ADDENDUM NUMBER - 1

DATE: August 5, 2024

JOB NO.: 2020-25

**Proposed Mexican Restaurant
8601 West Dodge Road, Suite 101
Omaha, NE**

DATE: 07/24/24
 SHEET: E1.1

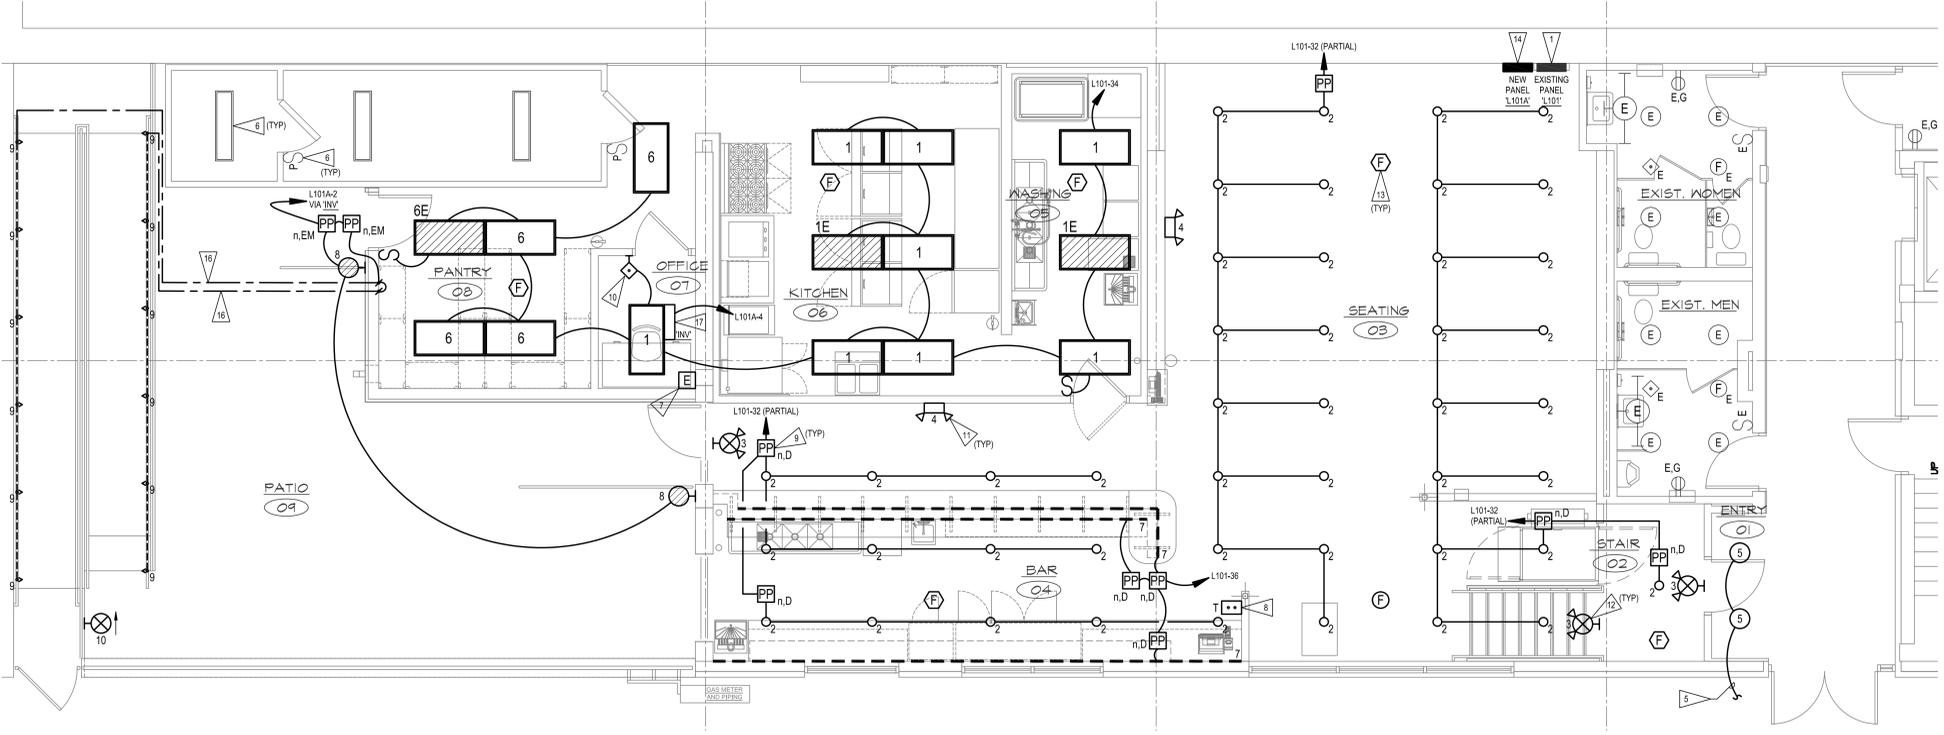
ITEM NO. 1: Sheet E1.1, Lighting Fixture Schedule: Added note #7 noting an "as equal" manufacturer.

NOTES:
 1. FIXTURE SHALL BE CONSIDERED EQUAL AS MANUFACTURED BY COLUMBIA, DAY-BRITE, COOPER, AND H.E. WILLIAMS.
 2. CONTRACTOR SHALL VERIFY LIGHT FIXTURE CATALOG NUMBER & INSTALLATION REQUIREMENTS PRIOR TO ORDERING.
 3. LAMP TYPE DESCRIPTION: LED-LIGHT EMITTING DIODE
 4. REFER TO ARCHITECTURAL PLANS FOR RUN LENGTHS REQUIRED. LUMINAIRE SHALL BE CONTINUOUS FOR ENTIRE LENGTHS. PROVIDE ACCESSORY MOUNTING CABLE AND ALL REQUIRED HARDWARE FOR INSTALLATION PER MANUFACTURER'S INSTRUCTIONS.
 5. SEE ARCHITECTURAL DRAWINGS FOR EXACT LOCATION AND MOUNTING HEIGHT.
 6. COORDINATE BEZEL, COLOR, FACE TYPE AND INSTALLATION OF LIGHT WITH ARCHITECT, RAILING VENDOR AND GENERAL CONTRACTOR PRIOR TO ROUGH IN.
 7. FIXTURE SHALL BE CONSIDERED EQUAL AS MANUFACTURED BY LLI LIGHTING.
